**Reference** 22/0783/MFUL

**Proposal** Construction and operation of a ground mounted solar farm, with permission being required for 40 years, comprising solar arrays, equipment housing, sub-station, fencing, ancillary equipment, landscaping and associated development

**RECOMMENDATION: Approval with conditions**

<b>Committee Date: 13.06.2023</b>
<b>Whimble And Rockbeare (Whimble)</b>	<b>22/0783/MFUL</b>	<b>Target Date: 08.08.2022</b>
<b>Applicant:</b>	<b>Aura Power Developments Limited</b>	
<b>Location:</b>	<b>Land East Of Rutton Farm Rull Lane</b>	
<b>Proposal:</b>	<b>Construction and operation of a ground mounted solar farm, with permission being required for 40 years, comprising solar arrays, equipment housing, sub-station, fencing, ancillary equipment, landscaping and associated development.</b>

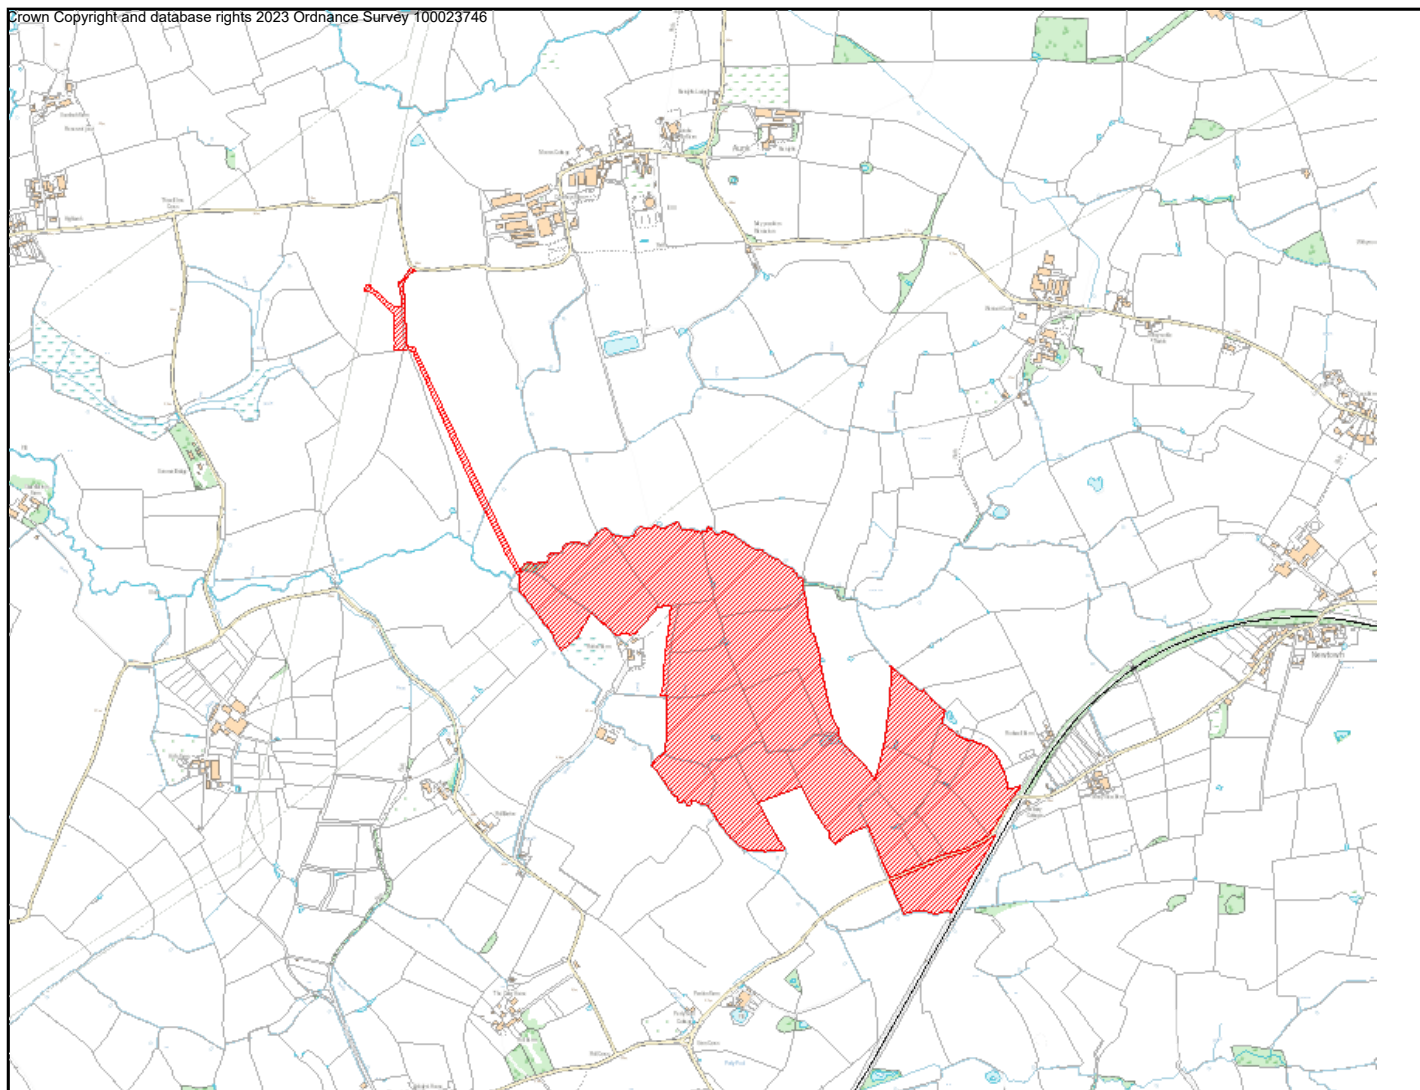
The plans are presented in A3 format at 1:5000 scale. At this scale the detail indicated is unclear and dimensions shown on the drawings are not legible. For clarity the drawings should be presented at a recognised scale on A1 or A0 sized drawings. Additional dimensions should be added to show offsets of security fencing from existing hedge lines and where there is no security fence the offset from the panels to existing hedgerow. The location of security gates, transformers and other structures should be more clearly marked.

The arrangement drawing shows panels standing 3m high with 2.1m spacing between rows. By comparison the panel layout for the recently consented Paytherden Solar Farm to the north provided for 2.5m panel height with 3.2m width aisles between. The proposed additional 500mm height of the panels will add to visual impact particularly in near views and will cast additional shade which combined, with the narrow aisle width will severely limit the creation of a dense grass sward between panels.

Transformer units stand 2.9m high and are set on raised platforms typically 500m above existing ground level resulting in a net overall height of the units of 3.4m. By comparison the transformer detail for Paytherden is shown resting on existing ground level with the units standing 2.6m high. The design of the transformer units should be reconsidered to reduce height to that of Paytherden.

The proposed layout is schematic and given the extent and scale of the proposals detailed plans are required showing relationship to existing site features, existing and proposed levels and the extent of any associated earthworks.
